# CITY OF ALBUQUERQUE

RE: **Lot 3 Block 8 Volcano Cliffs Unit 18 SAD 228  
6504 Papagayo NW  
Grading and Drainage Plan  
Engineers Stamp Date 6/25/2020 (D10D003O3)  
Pad Certification Date 6/25/2020**

## DRAINAGE AND TRANSPORTATION INFORMATION SHEET (REV 6/2018)

ENGINEER'S SEAL	LOT2 BLK8 U18 VOLCANO CLIFFS SUB. 6504 PAPAGAYO ROAD N.W.	DRAWN BY DEM
		DATE 11-20-19
6504 PAPAGAYO RD LOT 2 BLK U18 VC DWS		
6/25/20	GRADING AND DRAINAGE PLAN	
	 <i>Rio Grande Engineering</i> 1608 CENTRAL AVENUE SE SUITE 201 ALBUQUERQUE, NM 87106 (505) 872-0899	SHEET #  C1
DAVID SOULE P.E. #14522		JOB #  _____

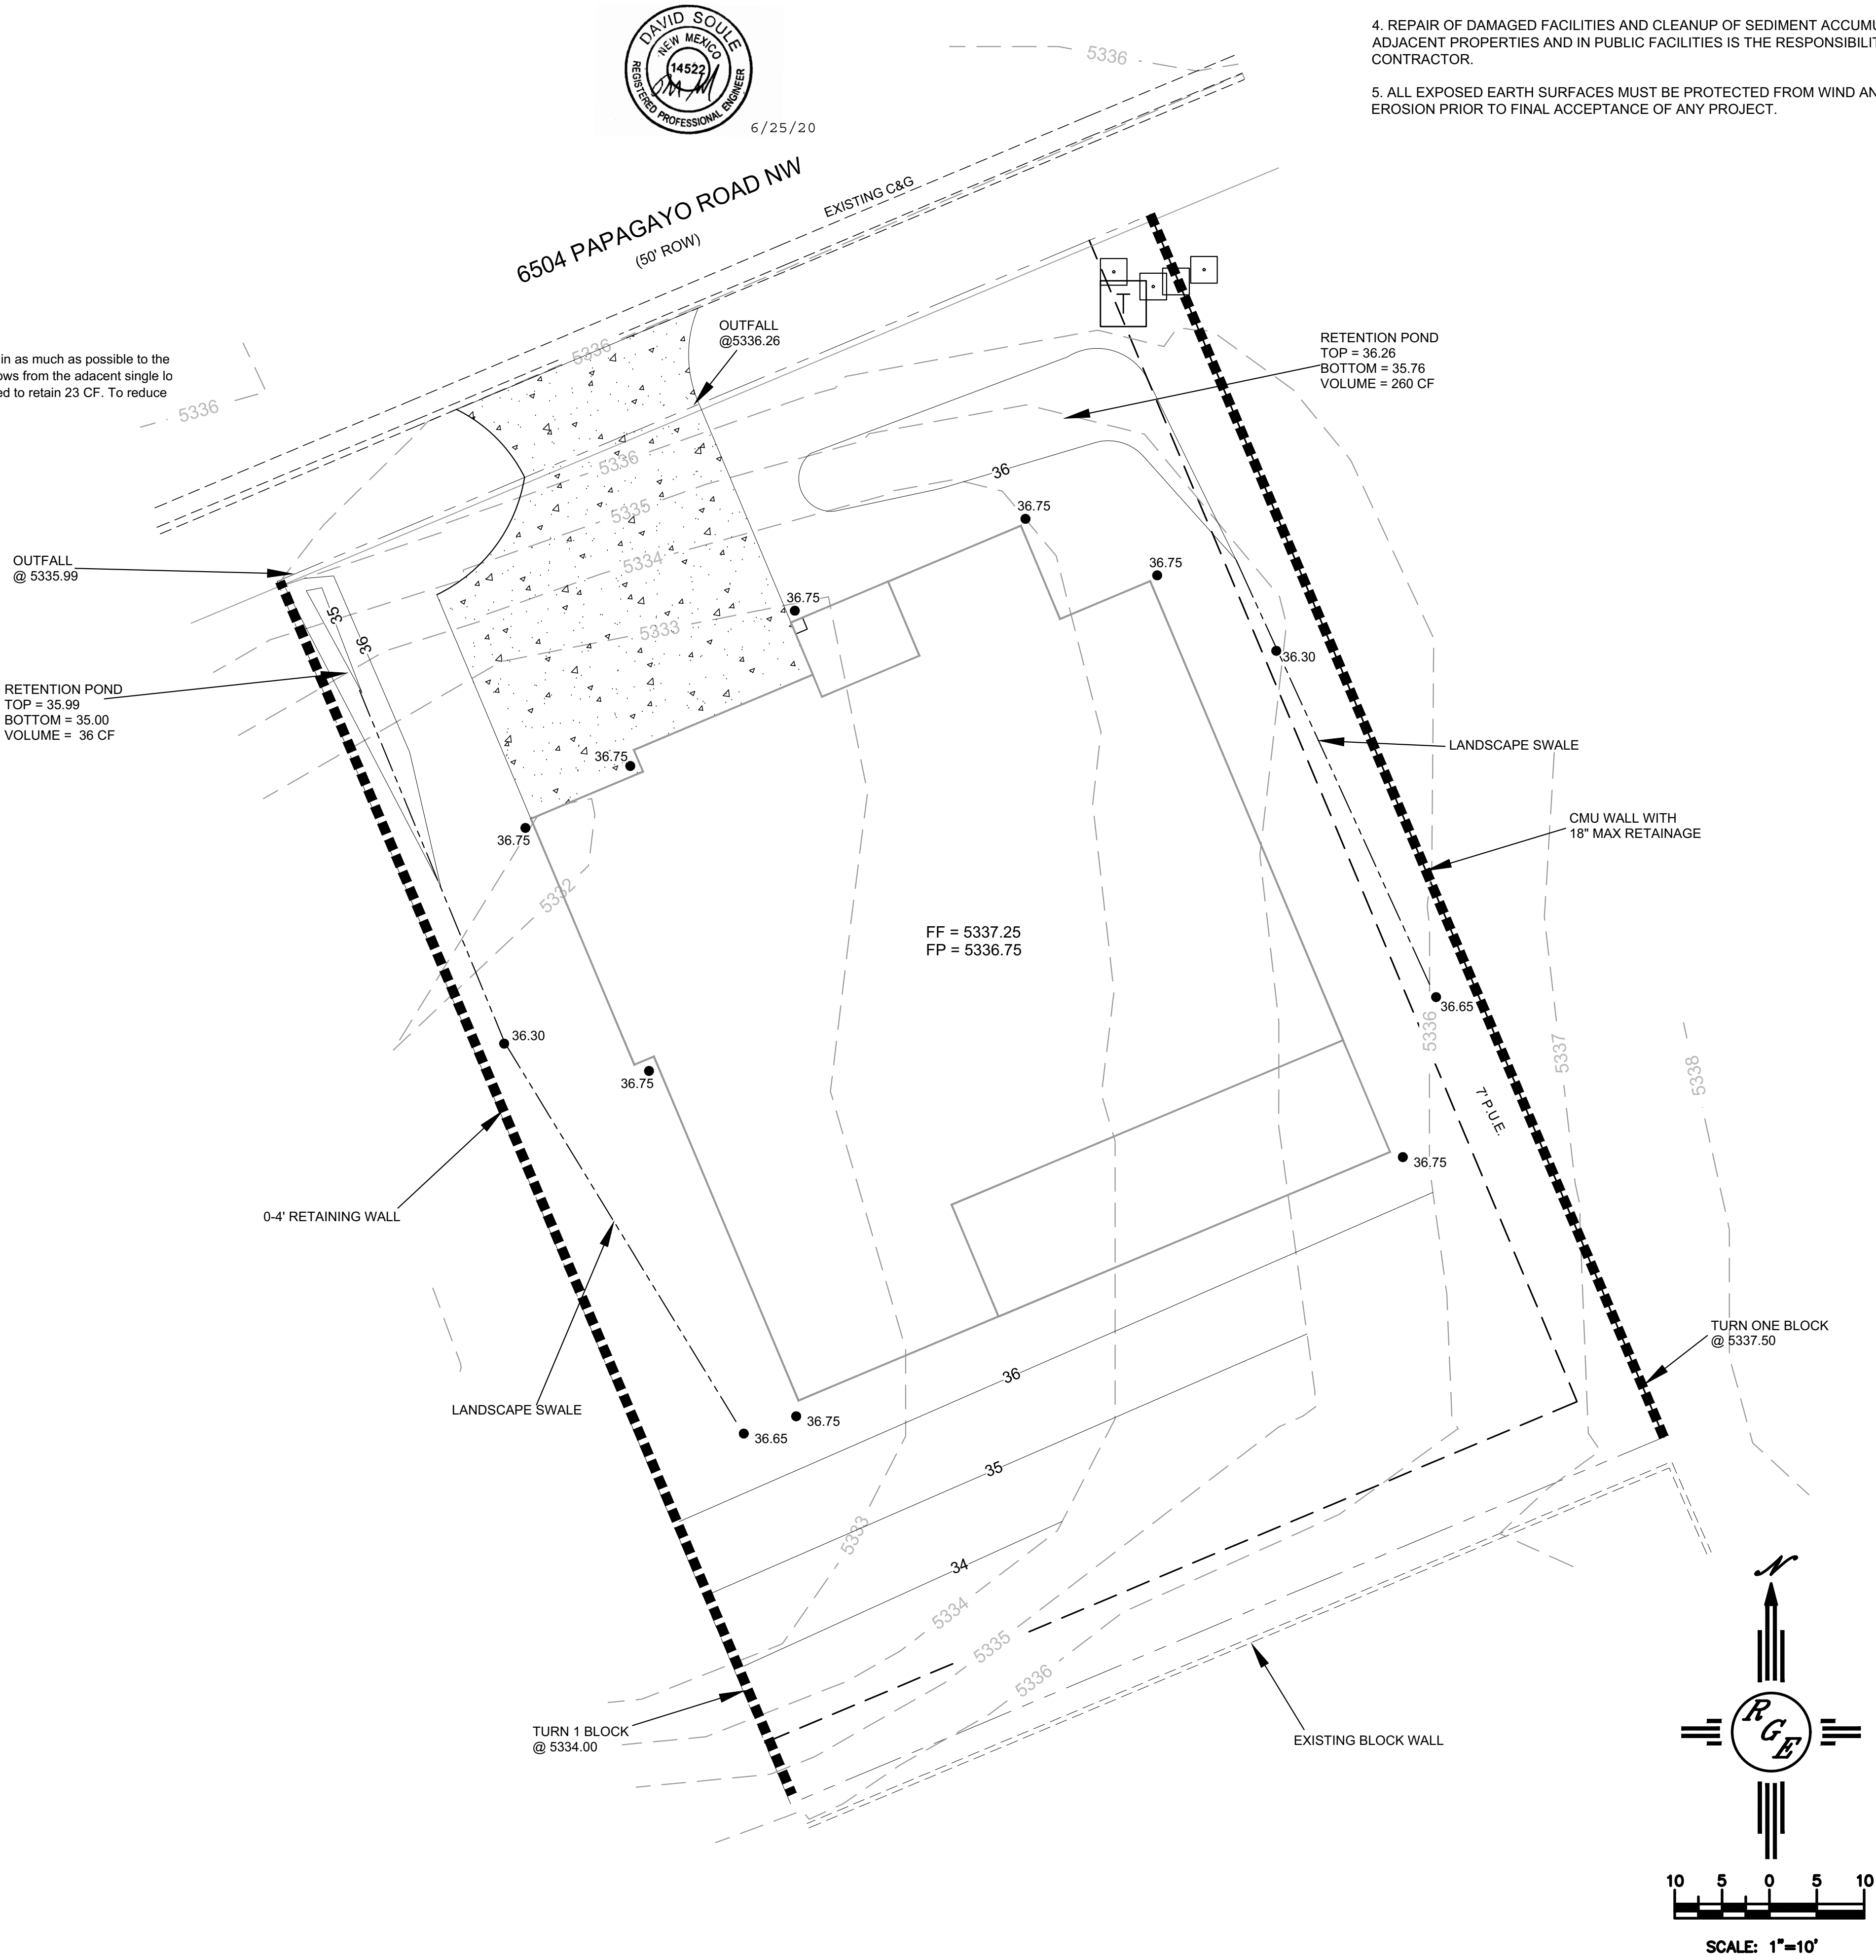
Based upon the information provided in your submittal received 6/24/2020, this plan is approved for Building Permit.

**Reiterate to the Owner/Contractor that a separate permit for a garden/retaining wall must be obtained, with the approved G&D plan dated 6/25/2020 and Pad Certification Date 6/25/2020.**

Prior to Certificate of Occupancy release, Engineer Certification per the DPM checklist of this plan will be required.
